**Environmental
Protection Agency**

RE: LAKE COUNTY
PAINESVILLE TOWNSHIP
SPRING LAKE MOBILE HOME PARK
NPDES PERMIT NO. 3PV00120
APPLICATION NUMBER OH0134694

On May 22, 2012, this writer conducted a compliance evaluation inspection of the wastewater treatment plant (WWTP) that serves the above referenced facility. The purpose of the inspection was to evaluate the WWTP's operation and maintenance condition, and to evaluate the facility's compliance with National Pollutant Discharge Elimination System (NPDES) permit.

001

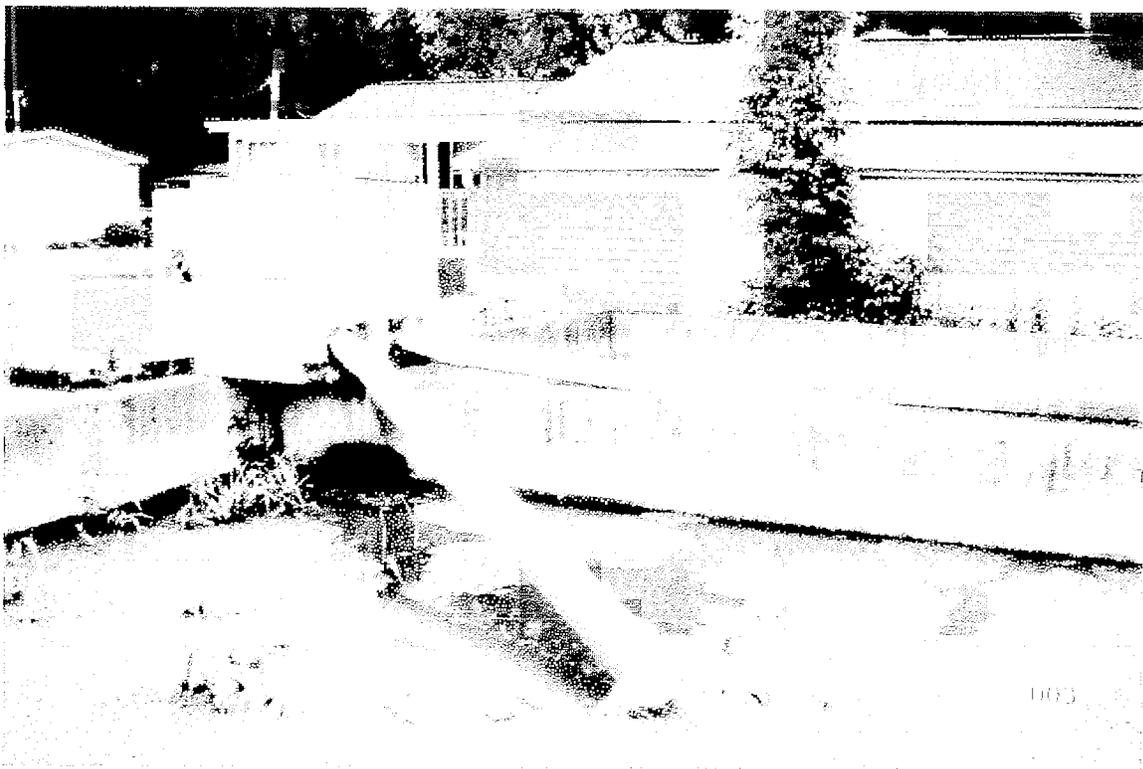
- The condition of the filter distribution box is poor. The filter bed distribution box was leaking excessively at the pipe entrance to the box. Excessive leaking was occurring at the distribution arms leaving the distribution box. The cement grout was cracked and leaking. The use of flexible, watertight gaskets is recommended. The concrete distribution box was leaking at the bottom. The concrete has crumbled. Immediate steps must be taken to repair the distribution box and the associated piping.

- Photograph 001 Distribution box pipe entrance. Cement grout crumbling.
- Photograph 002 Distribution box pipe entrance. Cement grout cracked and leaking.
- Photograph 003 Filter bed ponded with sludge, algae, and vegetation. Cement grout crumbling and leaking at distribution arms.
- Photograph 004 Filter bed ponded with sludge, algae and vegetation.
- Photograph 005 Filter bed ponded with sludge, algae and vegetation.
- Photograph 006 Distribution box. Cement crumbling at bottom.
